ADDENDUM
NO. 4

Loy Norrix High School Mechanical Improvements
606 East Kilgore Rd
Kalamazoo, MI 49001

ADDENDUM NO. 2

| ARCHITECT'S PROJECT NO.: | 21-807.00 |

SHEET NUMBER
E 405
21-807.00

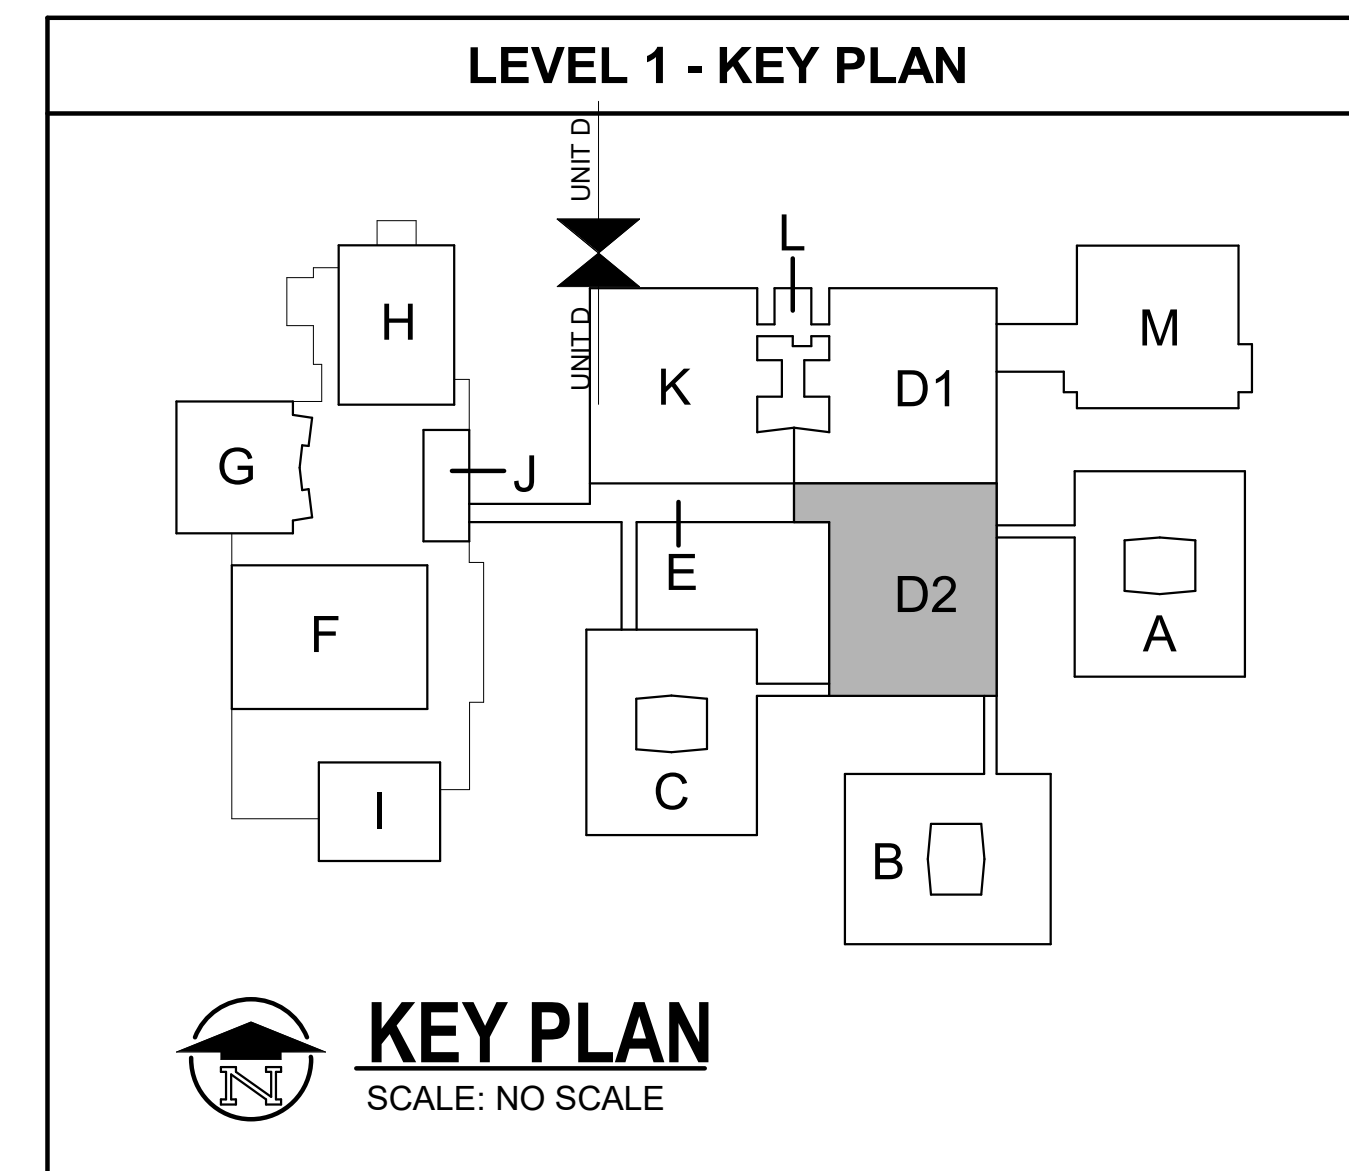
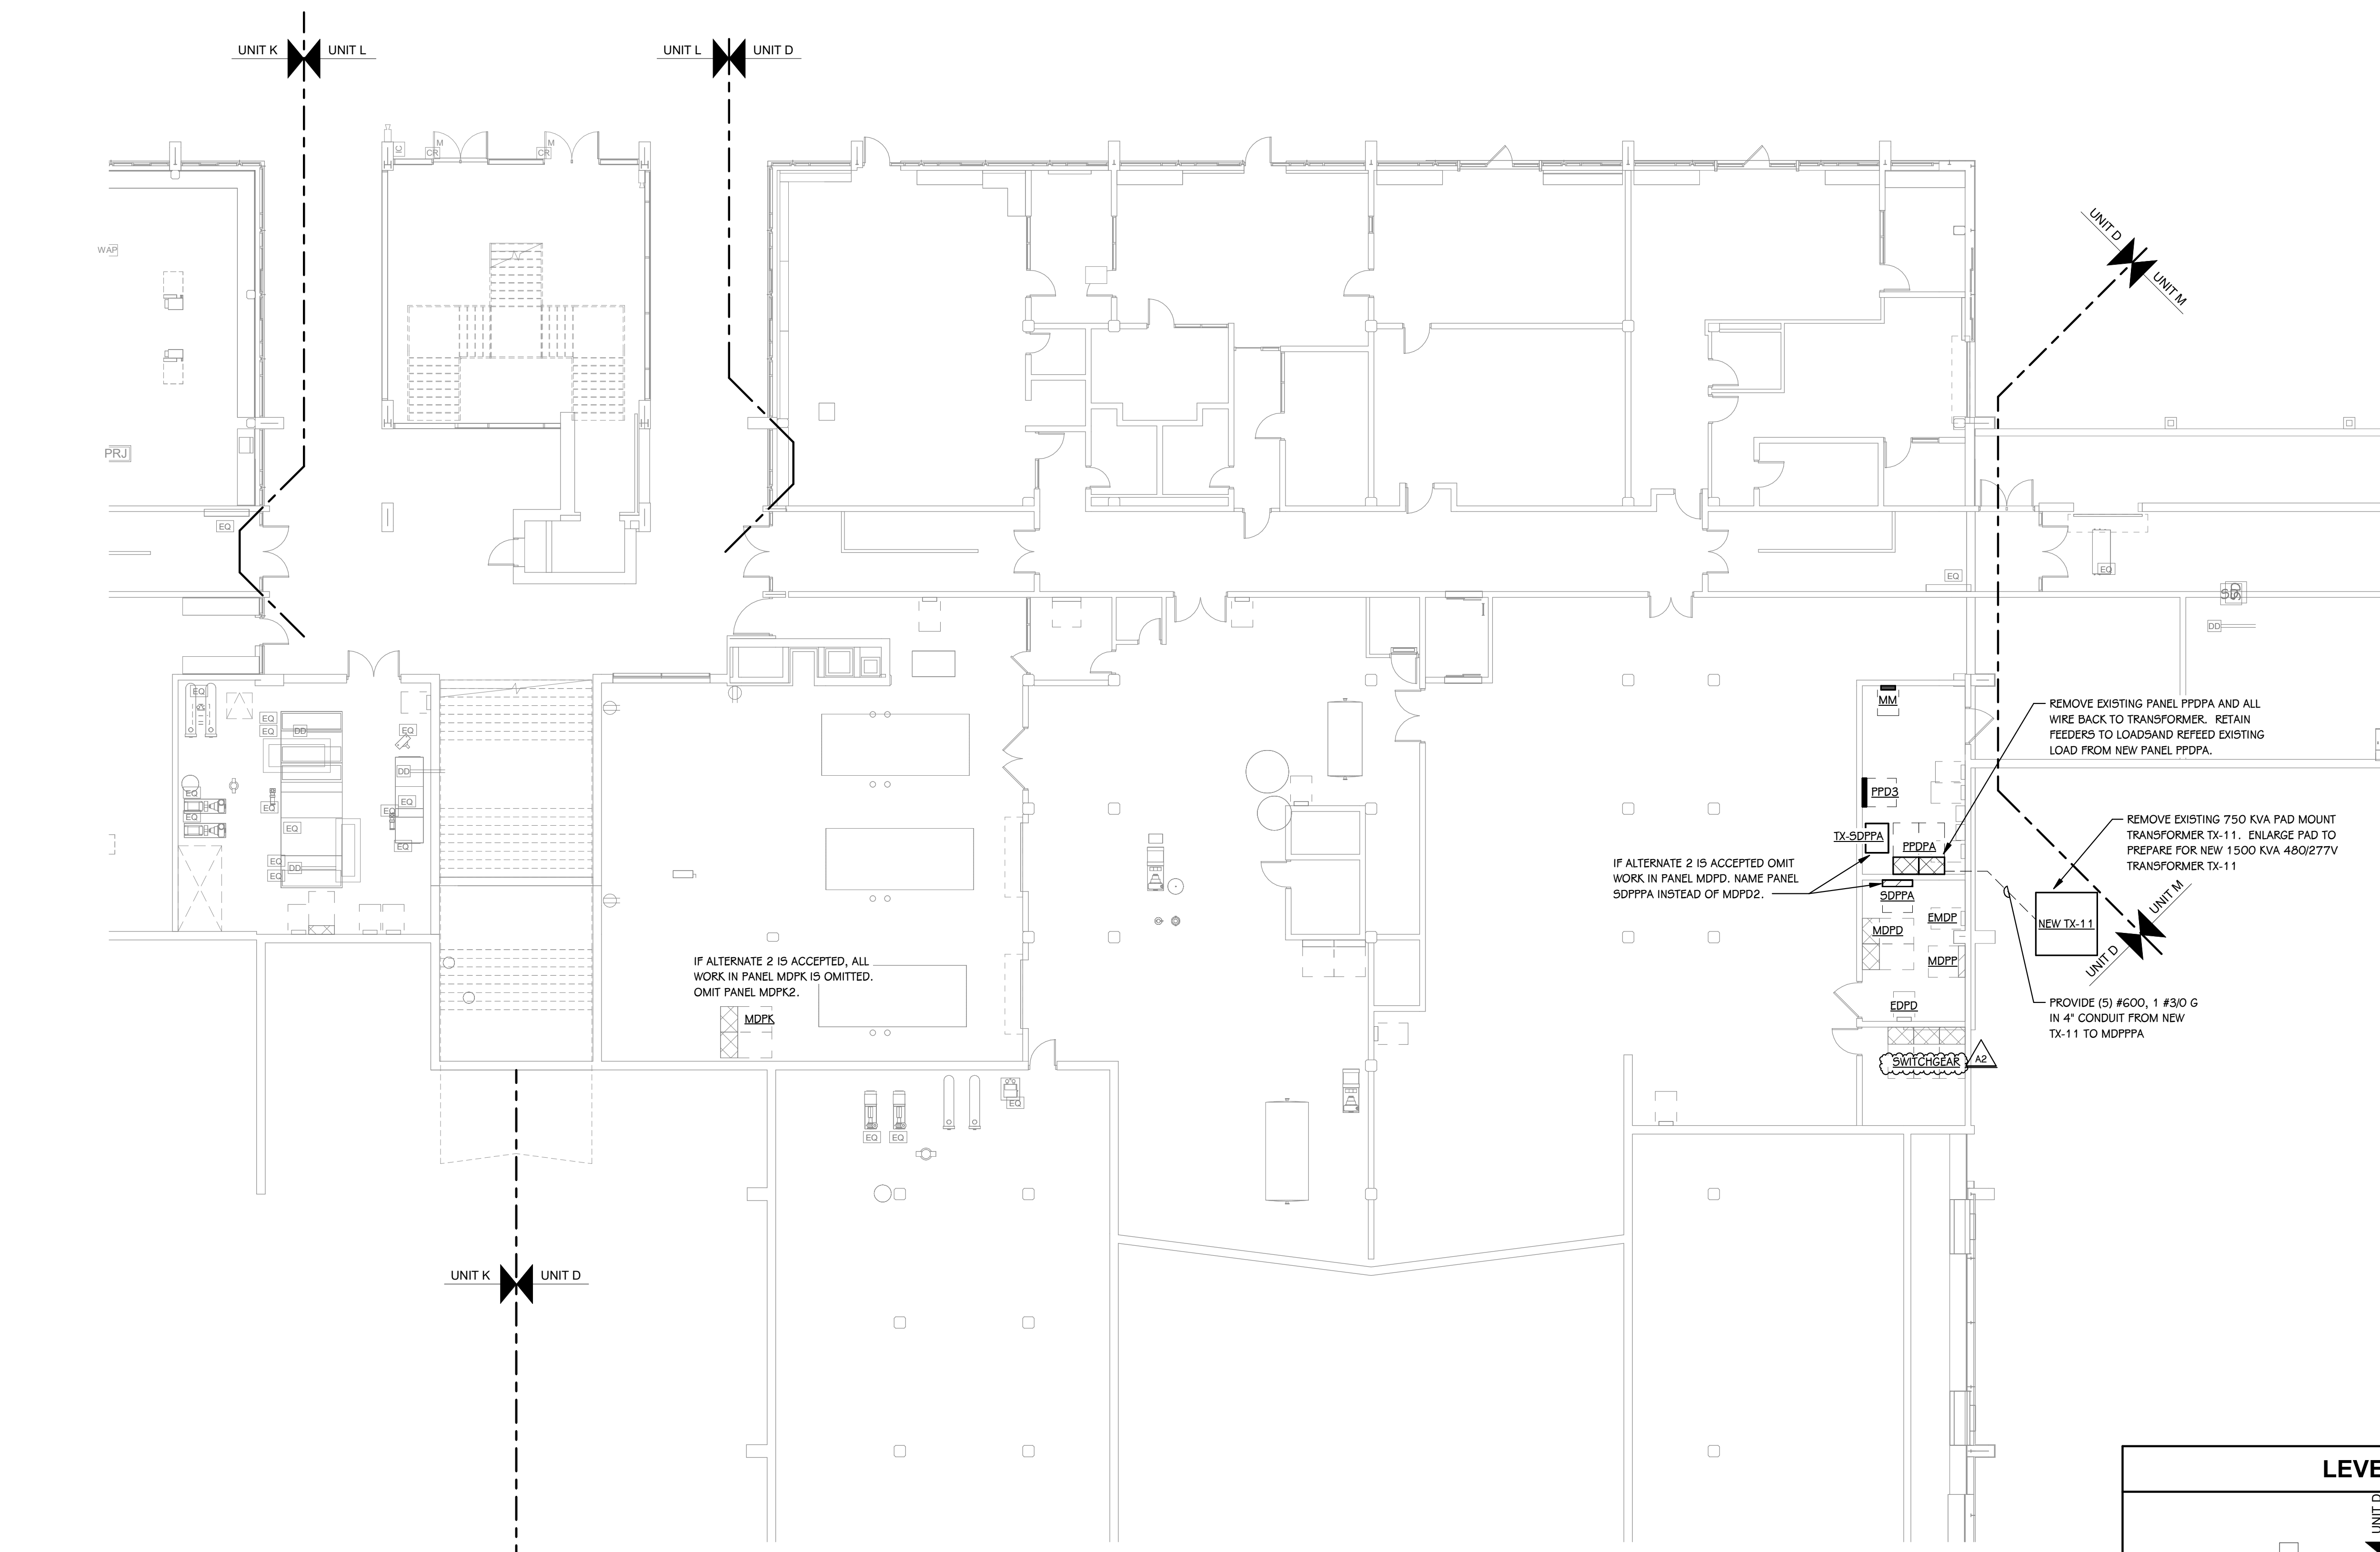
ADD-2 Item No. D-4 - Removed References to Electrical Panels with No New Work

Refer to Sheet(s): E403 and E405

Removed feeder for existing panel to remain LPA3

FIRST FLOOR TECHNOLOGY PLAN - UNIT K
3/32" = 1'-0"

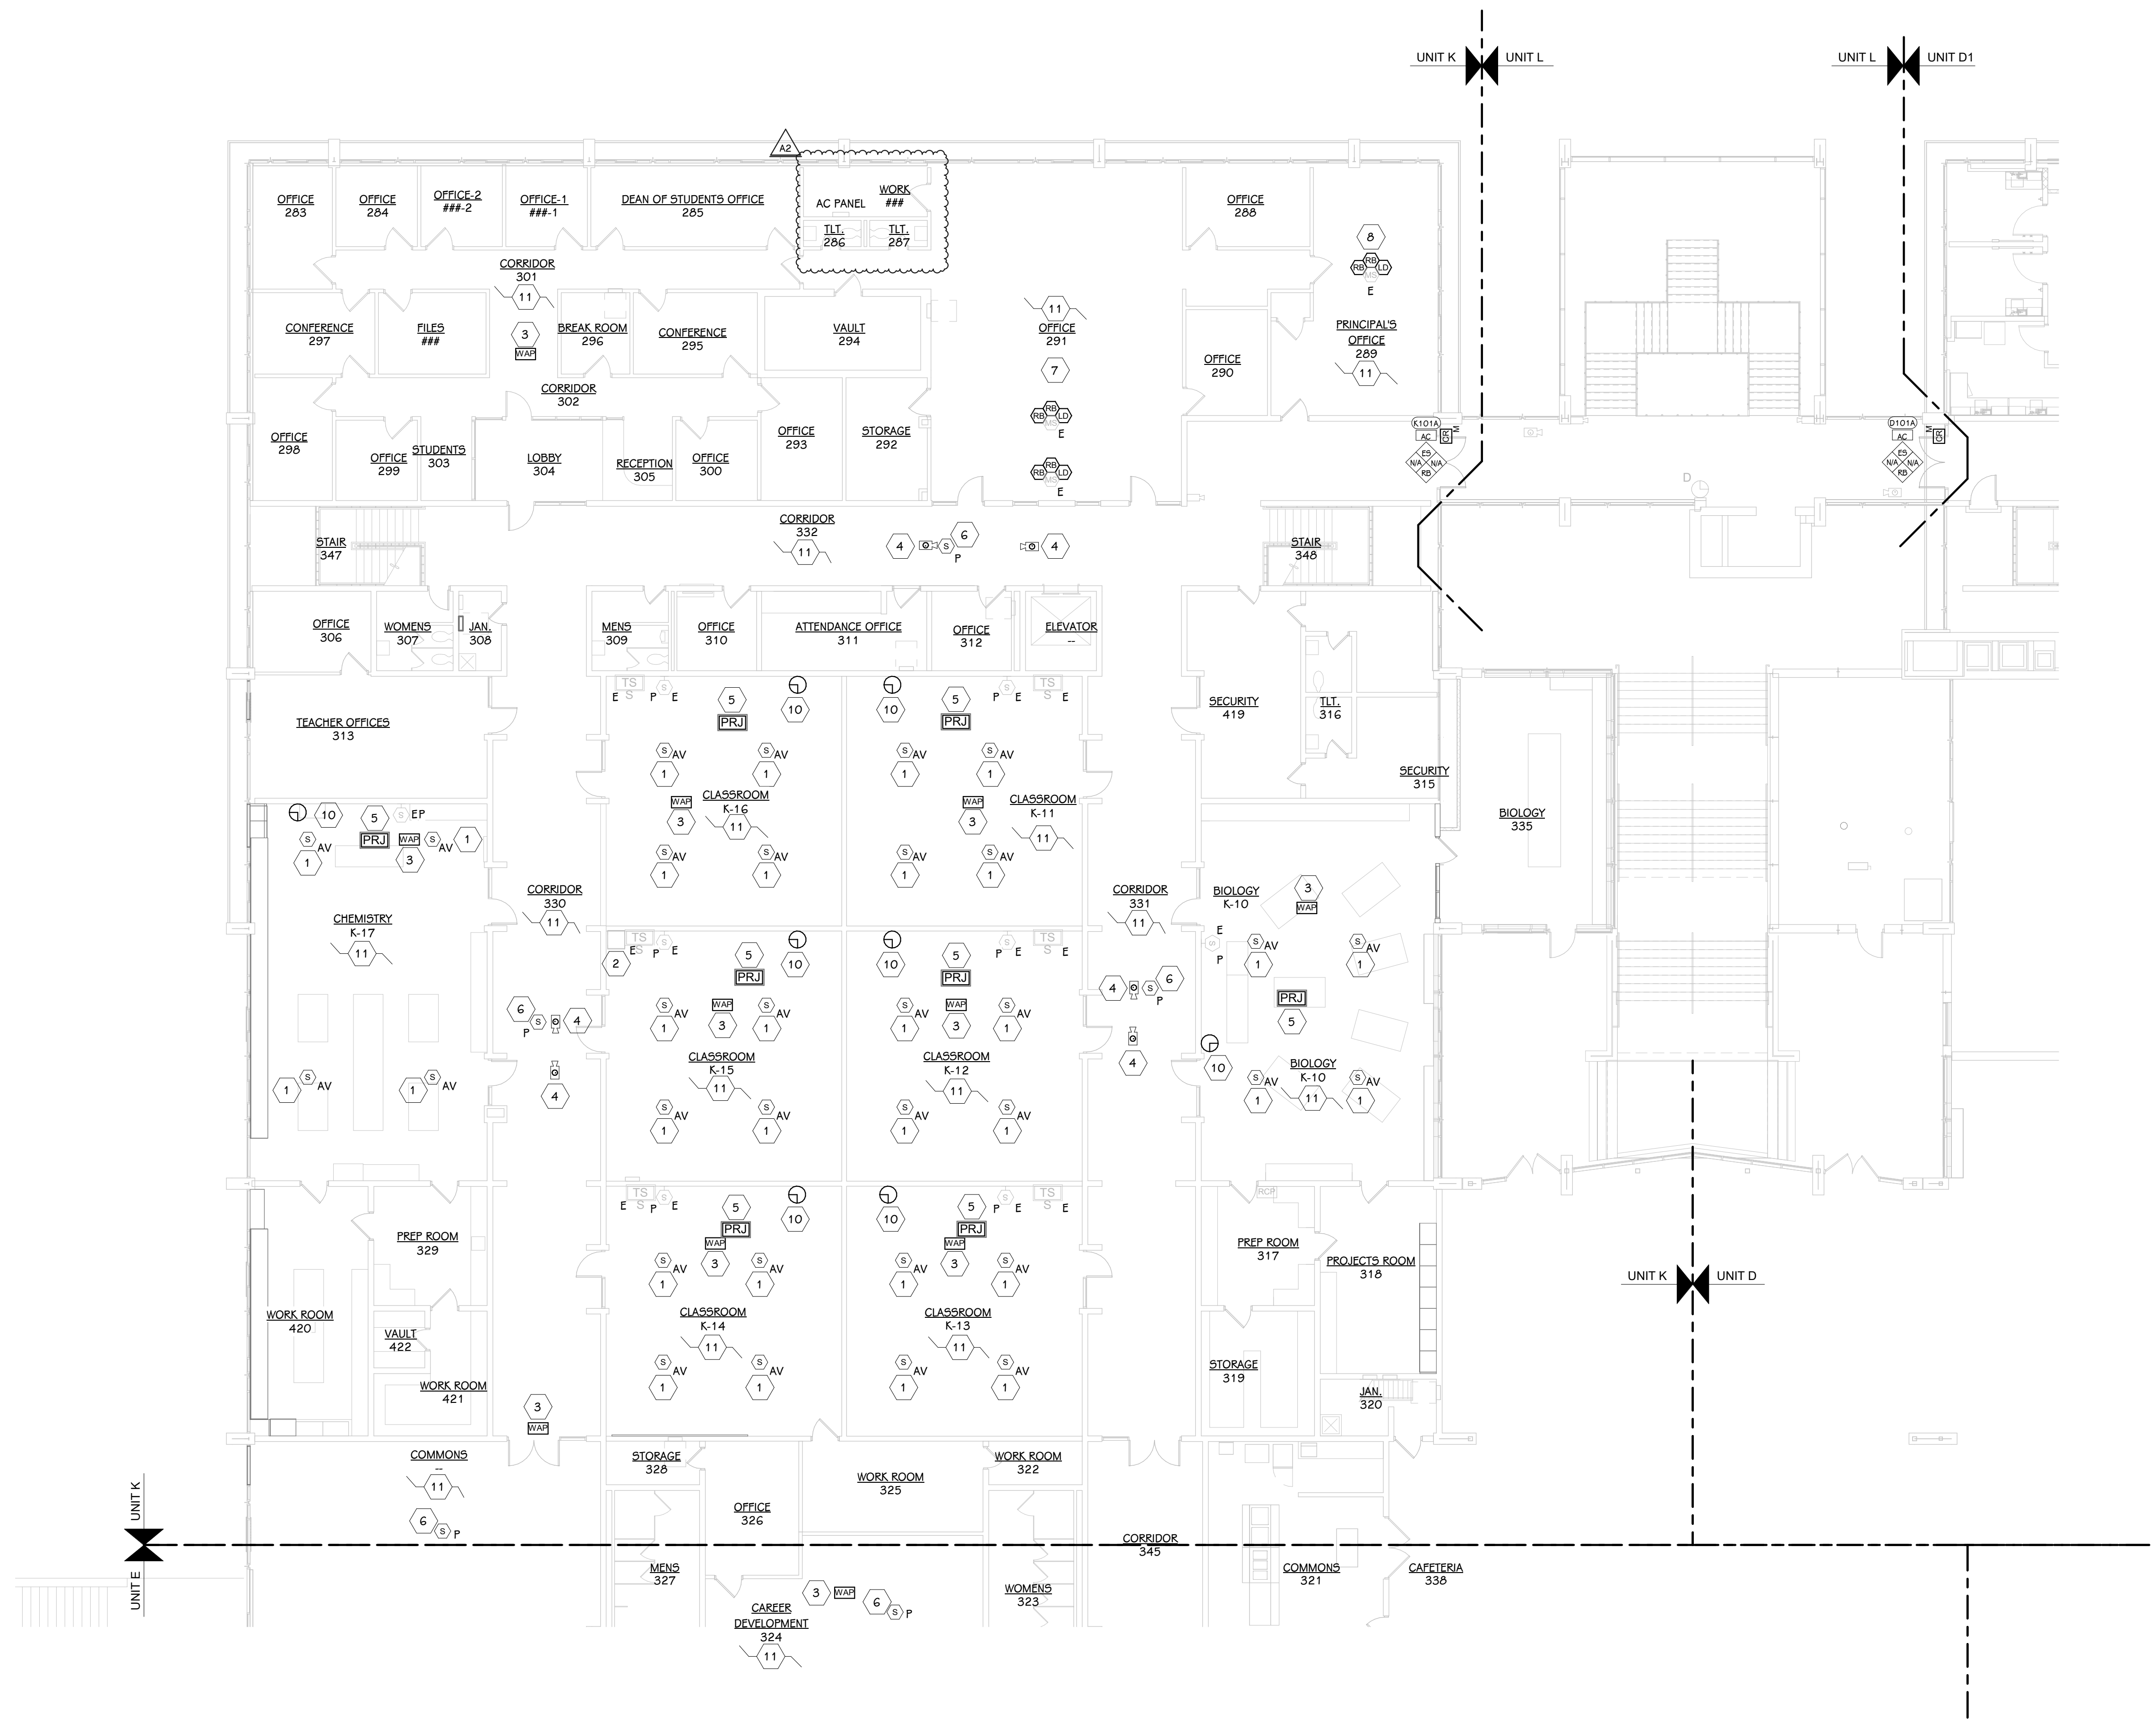
ADD-2 Item No. D-3 - Access Control Panel Location

Refer to Sheet(s): T 101K

Added access control panel location in the work room of main office 291.
